MEMORANDUM

SUBJECT: **Committee of Adjustment Variance Application**
329 Main Street North, Markham Village Heritage Conservation District
Proposed rear addition and front porch addition to an existing two-storey dwelling

FILE: A/119/21

Proposed Site Plan

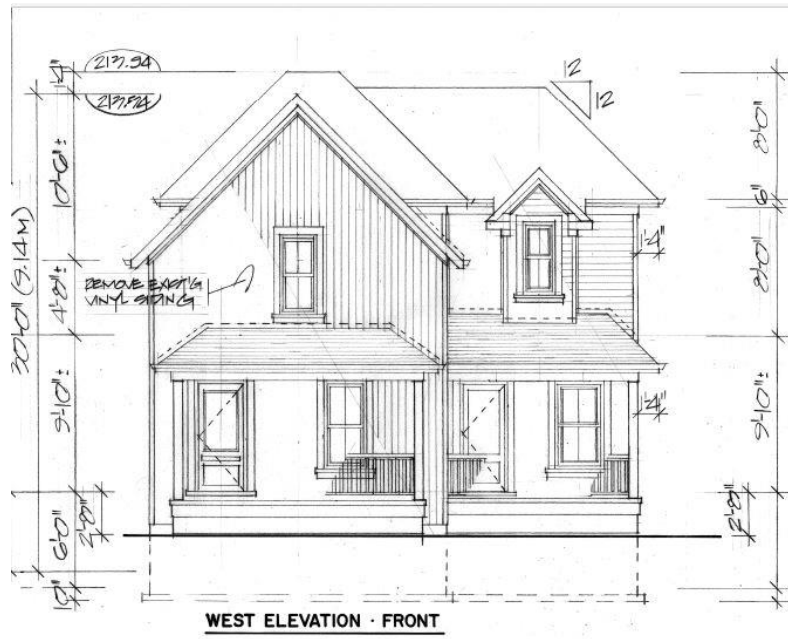
- The positioning of the driveway, while closer to the adjacent property at 327 Main Street North than permitted by the By-law, is dictated by the constrained nature of the site. As relocation of the existing heritage building to facilitate a private driveway that complies with the By-law would not be supported by policy contained within the MVHCD Plan, the positioning of the driveway as shown in the appended site plan was selected as the preferred option. The introduction of a driveway along the southern edge of the subject site will also allow for the partial removal and replacement of the existing shared driveway with new landscaping.

- A mature tree is proposed to be removed to accommodate the new driveway. Based on information provided by the applicant, the affected neighbour at 327 Main Street North is supportive of the tree removal.

Note that the ZPR confirmed three (3) variances rather than the four (4) indicated by the applicant above.
